CAMERON COUNTY PURCHASING

ADDENDUM # 1 - PAGE 1 of 5

RFP TITLE: ISLA BLANCA PARK UTILITY IMPROVEMENTS PROJECT

RFP NUMBER # 250502

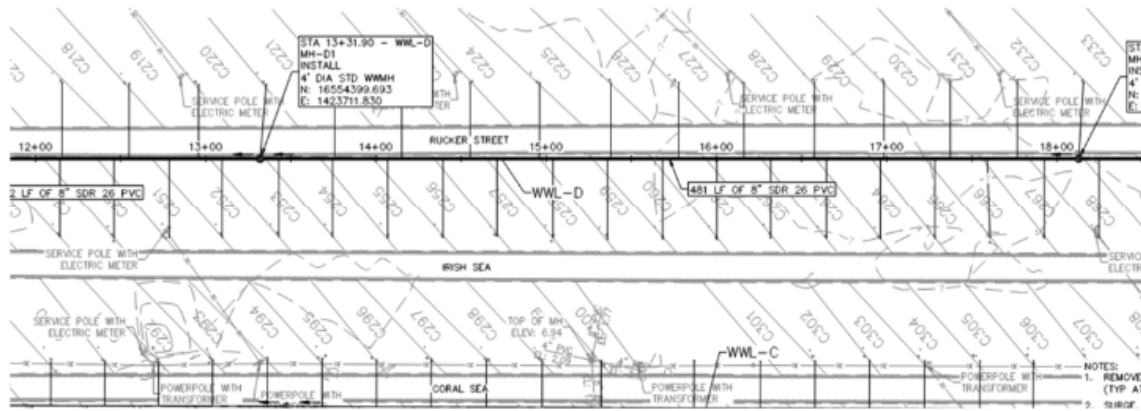
- A. Can you provide drawings or references that show where the pavement removal and replacement is required?

Limits of pavement repair shall be determined in accordance with Detail No. 4 "Trench Backfill for Wastewater Lines and Pavement Repair for Utilities" Shown on Sheet C33 Utility Details. As trench width on detail is reflected in Pipe Diameter + 2 feet, the trench is preferred to be completely out of the pavement limits as feasible to minimize the amount of pavement repair during construction.
